客户图

SCALE:	N/A	UNIT	mm
SHEET:	1 of 1	PROJECTION	
DATE:	2019.07.1	VER.	A-1

DESIGNED BY:		DWG. NO.	YZ00315035R-01
CHECKED BY:		TITLE:	Pogo Pin
APPROVED BY:

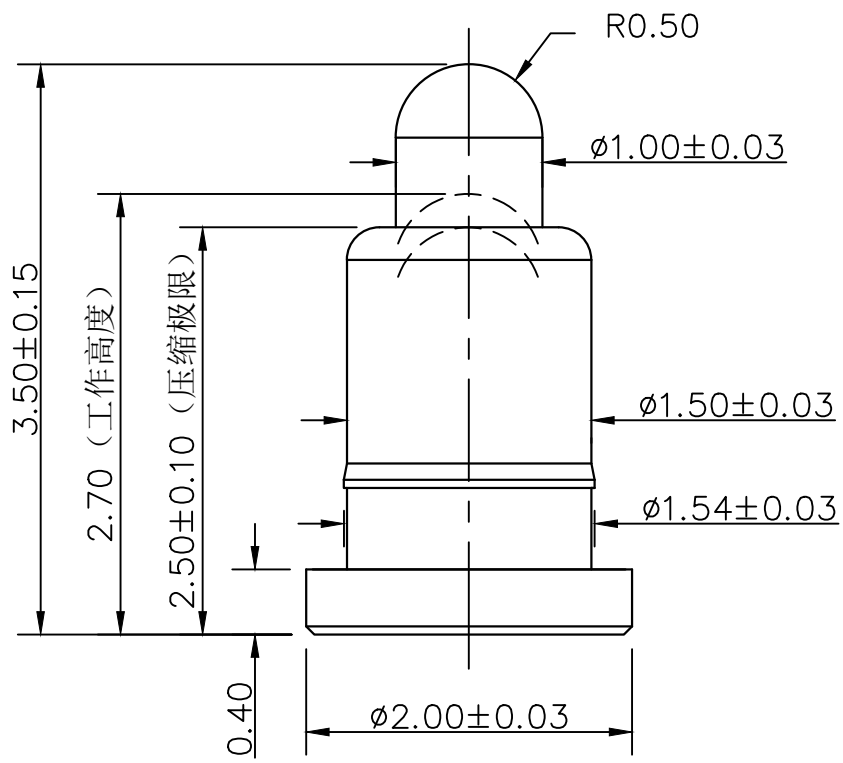
NO.	ECN NO.	DESCRIPTION	DATE
1		首次发行	2014.05.31
2	A-1	派美特要求弹簧镀金减小阻抗	2019.07.1
